Access Compliance Report Public Rights-of-Way (Pedestrian Signals)

Main Street: 17TH_ST Cross Street: PROSPECT_AVE Location: SW

ADA ID: SGRK220124103338 Signal Type: One Push Button-Non APS Overall Compliance: No Severity Scores: BTN 1: 35 BTN 2: N/A No BTN: N/A

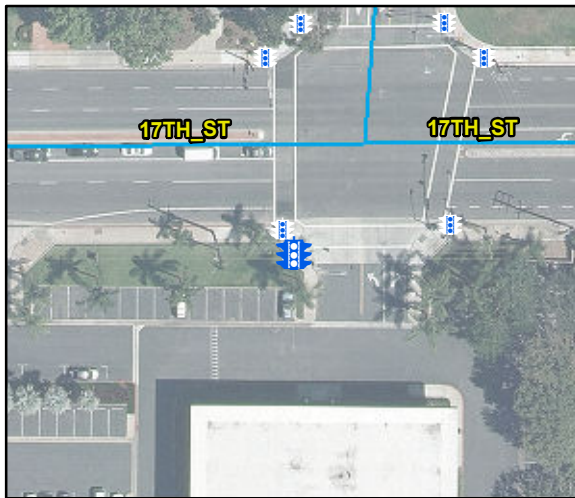
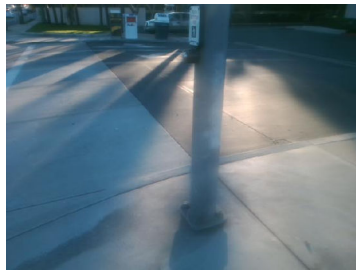
OC Std/PROW: MUTCD 4e.08, R404.2

Possible Solutions: Replace Signal Push Button With APS Button. Remove & Relocate Sign.
